APPLICATION NO.	FILING DATE	FIRST NAMED INVENTOR	ATTORNEY DOCKET NO.	CONFIRMATION NO.
09/964,639	09/28/2001	Dong-Gyu Kim	6192.0186.AA	1991

Office Action Summary

DETAILED ACTION

FIG. 7

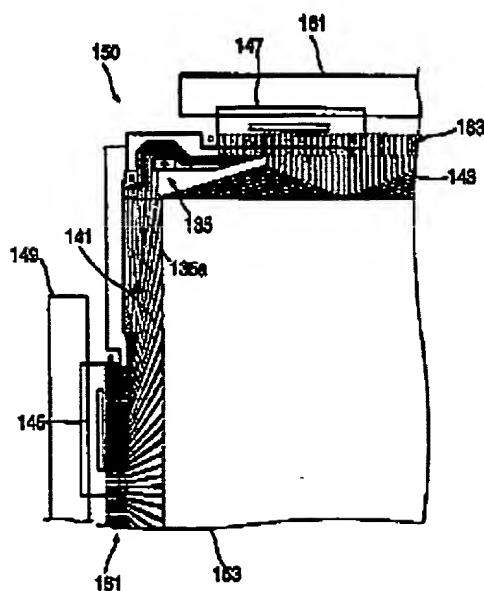
11. Park discloses and shows in Figs. 7 and 8, a display device, comprising:

- a first substrate having a plurality of gate lines (141) and a plurality of data lines (143);

- a plurality of thin film transistors (T) electrically connected to the gate lines (141) and the data lines (143);
- a plurality of pixel electrodes electrically connected to the thin film transistors respectively (page 1, paragraph 0006);
- a plurality of gate driving ICs (145) to output gate signals to the gate lines (141) (page 3, paragraph 0035);
- a plurality of source driving ICs (147) (applicant's data driving ICs) to output data signals to the data lines (143) (page 3, paragraph 0035); and
- a plurality of gate transmitting lines (135) (applicant's interconnection lines) apply gate control signals to at least one of the gate driving ICs (145) (page 3, paragraph 0035).

Park differs from the instant invention because he does not explicitly disclose the claimed black matrix overlapping at least one of the interconnection lines.

It is common and known in the art to form black matrix on a substrate opposite to the substrate where the gate lines and the data lines are formed and outside the display area (interconnection lines are typically formed outside the display area) so that it overlaps the interconnection lines in order to prevent light leakage and thus improve display quality.

Therefore, it would have been obvious to one of ordinary skill in the art at the time of the invention was made to modify the display device of Park by forming a black matrix such that it overlaps the interconnection lines so that light leakage is prevented and display quality is improved.

As to claim 39, Park also discloses and shows in Fig. 7 that the device further comprising a gate PCB (149) and a source PCB (151) (applicant's driving signal transmission film) wherein at least one of the data driving ICs (147) is mounted on the driving signal transmission film (151) (pages 3-4, paragraph 0054).

As to claim 40, it is clear from Fig. 7 of Park that the driving signal transmission film (149 and 151) outputs the gate control signals and the data signals to the interconnection lines and the data lines respectively.
